RE: Headrick Garage and Pool Addition Watercourse Classification Memo - CAO19-014

Wetland Resources, Inc. (WRI) recently received email correspondence from City of Mercer Island planning staff (date: August 26, 2019, subject line: FW: Headrick Project, CAO19-094&1905-249, Notice of Application for Critical Area Determination) requesting a response to comments made by the Muckleshoot Tribe. The following narrative re-states all comments made by the Muckleshoot Tribes as italicized, indented text, which are immediately followed by the applicant's response as justified, normal text. In short, this memo is intended to present data that supports the applicant's original assertion; that the on-site reach of Stream A does not meet criteria for designation as a fish-bearing watercourse.

Figure 1: Contributing Basin to Stream A

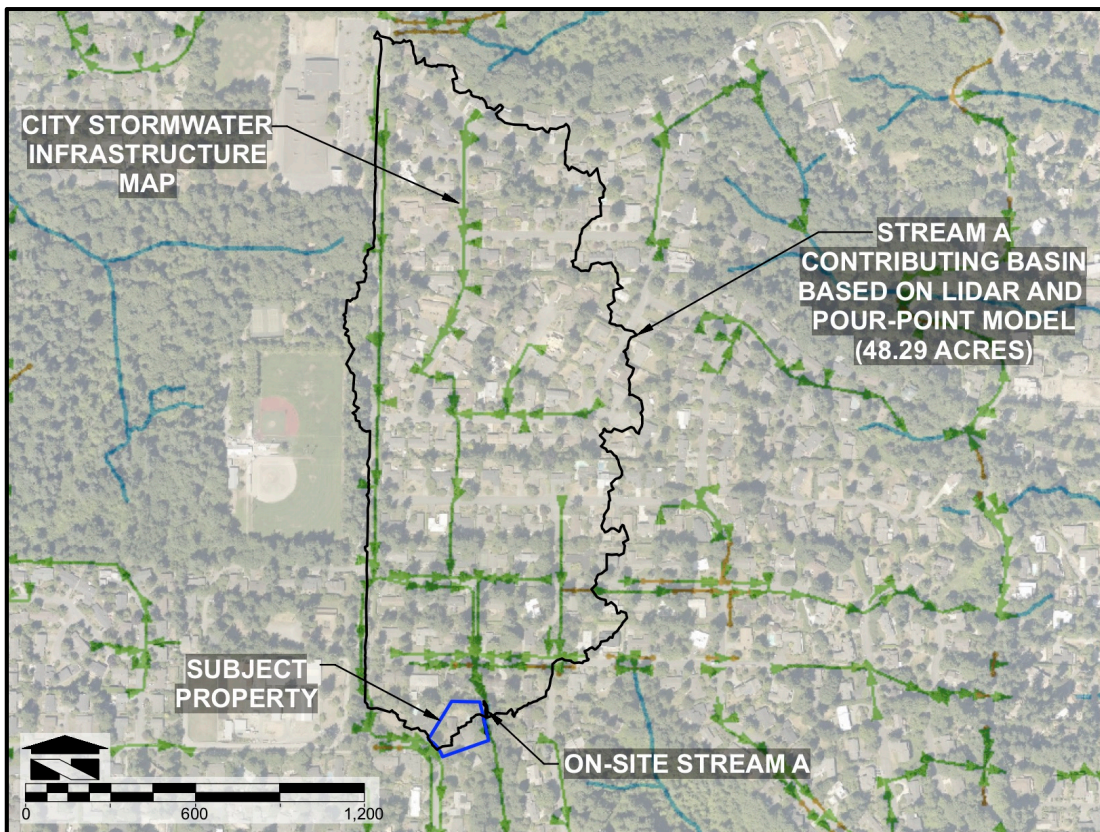
The WDNR maps are tool to make this determination initially; however, in the areas outside of commercial forest production districts, the maps were not developed with field data. Therefore, anyone using the WAC and maps needs to actually collect stream data to demonstrate if the physical criteria from above are met for presumed fish use. Part of this determination means determining if there are any natural barriers downstream. We are unaware of any such barriers but the City may data otherwise. If there are no known natural barriers, then stream data for bankfull width and streambed gradient needs to be collected by measuring 6-10 random samples on site and compare against the physical criteria. If it is met, the Stream is a Type 3/Type F fish bearing water based on presumed use.

Applicant's response: Downstream natural barriers that preclude fish use were documented by WRI staff during a recent sit visit. Assumptions, methodology, and findings are presented below.

Stream A discharges to an 18" PVC culvert in approximately the southeast corner of the property. Based on comparison with the City's stormwater inventory, and by constructing a pour-point model using publicly available LIDAR data, the contributing basin to the on-site portion of Stream A is 48.29 acres in total area.

Figure 2: Existing Site Conditions and Channel Measurement Location

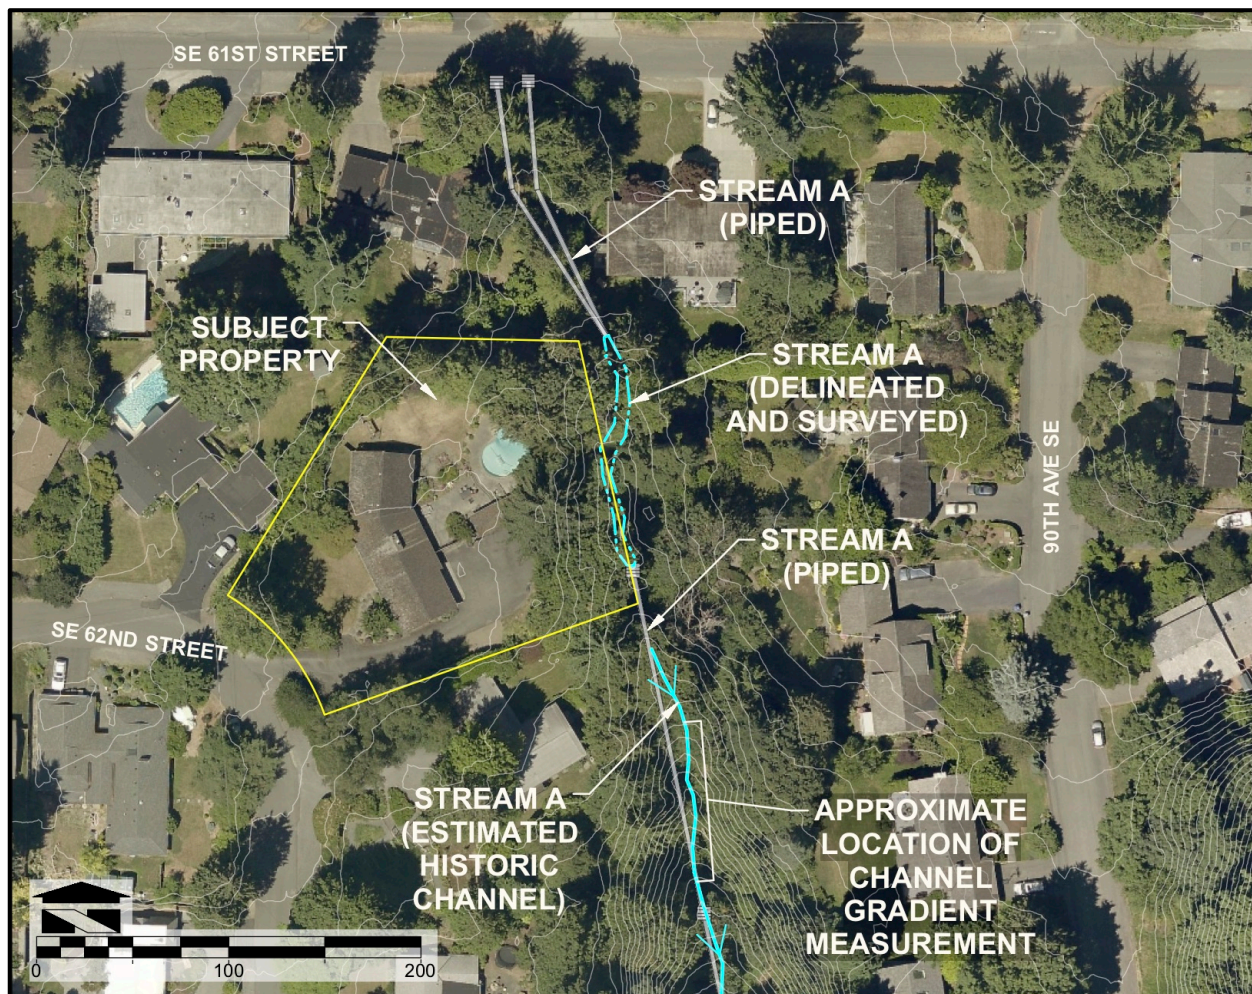
From a review of the site plan map showing the locations of the surveyed OHWM, it appears that the stream meets the criteria for bankfull width (i.e. >+2 feet). The streambed gradient is unknown at this time. More data is needed to establish the streams classification.

As previously stated, Stream A enters an 18” culvert located in approximately the southeast corner of the subject property. Based on the City’s stormwater inventory, that pipe daylights to an open channel several properties to the south (6250 89th Ave SE). Due to evidence of steep topography (exceeding 20 percent) using LIDAR-based elevation contours, channel gradient measurements were taken in the field within the adjacent property located at 6206 89th Ave SE, to determine stream gradient. Steep topography was physically observed in the historic channel of Stream A, similar to the findings of the LIDAR-based slope assessment. Figure 2 below depicts the location where historic stream channel gradient measurements were taken. The enclosed Watercourse Classification Maps also depict the location of field measurements.

Using a Suunto clinometer, surveyor’s rod (long fiberglass pole), and a 100-foot measuring tape, WRI staff conducted a channel gradient measurement in the field. This area was selected for field measurement based on a WRI analysis of elevation contours generated from publicly available LIDAR data that indicated a continuous slope exceeding 20 percent gradient for at least 88 horizontal feet. Due to the presence of dense, sight-obscuring vegetation, and limited site access, channel gradient was measured in two segments. The first segment was 55 feet in length (parallel to the sloping ground surface) and began at the lowest point of the historic channel. The second segment was 35 feet in length along the ground surface. Each segment was measured using the following method.

Each segment, as measured in the field, showed a slope angle of 21 degrees. Using basic trigonometry, it was determined that the horizontal distance of the first segment (55 feet along a 21° slope) equals 51.3 feet, and that the horizontal distance of the second segment (35 feet along a 21° slope) equals 32.7 feet. Therefore, a continuous 21° slope was physically observed for a total horizontal distance of 84 feet. Farther downstream of the measurement location, channel gradient appeared to become less steep. Above the upstream limits of measurement, slope appeared to be as steep or steeper than the measured segments. Based on the total area of the contributing basin (48.29 acres), and the observed 21° slope, the on-site portion of Stream A does not meet any of the presumption-of-fish thresholds established in the WAC. Stream A is correctly classified as a Type III/Type Ns watercourse in the vicinity of the subject property.

Applicant's response: The on-site portion of Stream A meets the criteria for bankfull width, but is upstream of a natural fish passage barrier according to the WAC (greater than 16 percent slope in with a contributing basin less than 50 acres), and an artificial fish passage barrier (culvert under E Mercer Way). See detailed discussion above. In the vicinity of the subject property, Stream A is correctly classified as a Type 3/Ns stream pursuant to the water typing rules of WAC 222-16-031, and pursuant to the rules in effect at the time of complete application for the current project. In the vicinity of the project, current and future development should not be subject to regulatory setbacks associated with fish-bearing streams based on the findings of this memo.
